Instructions To Modify Original KTM 950SE Side Covers To Suit the 30 litre Safari Fuel Tank

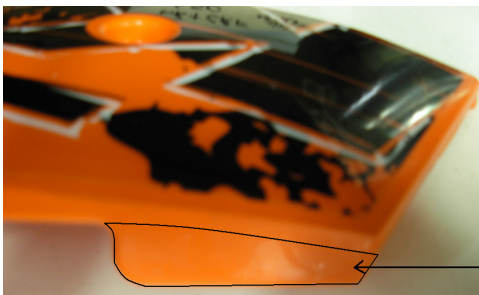
This part needs to be cut off to leave about an 8mm flange.

This part needs to be cut off to leave about an 8mm flange.

This part needs to be cut off to leave about an 8mm flange.

This part needs to be cut off. The part being removed should be about 12mm wide.
